EAGLE RISING, FILING NO. 1

FINAL DRAINAGE REPORT

AUGUST 2015

SF-18-029

EAGLE RISING HYDROLOGY MAP PROPOSED (ON-SITE)

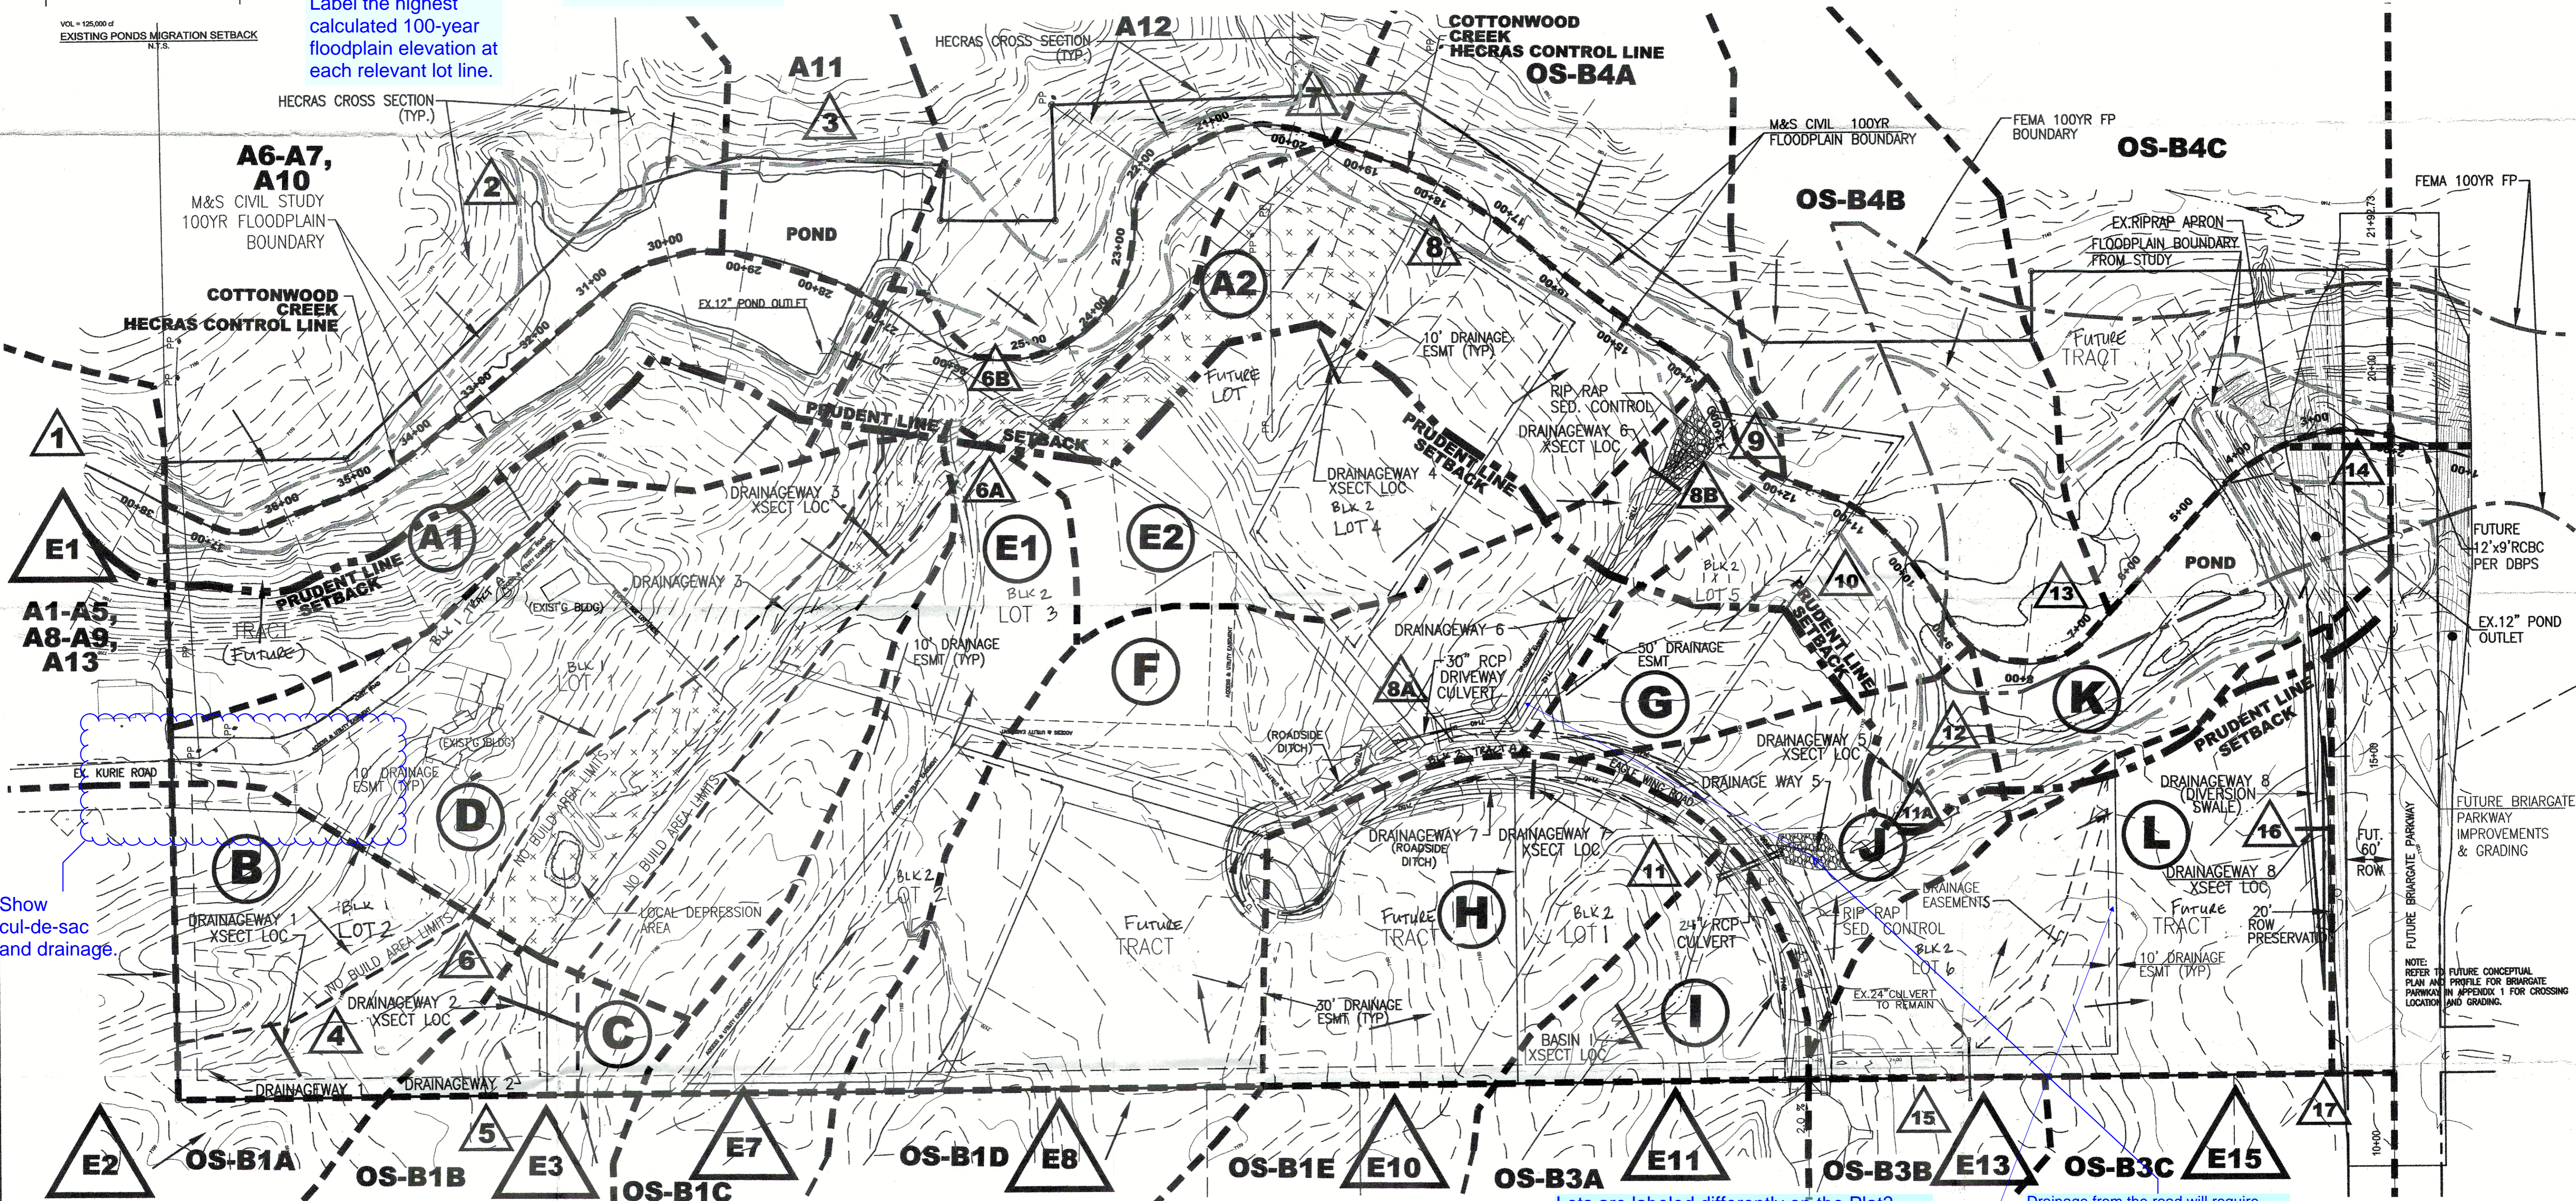
Show ultimate channel stabilization measures.
Label the highest calculated 100-year floodplain elevation at each relevant lot line.
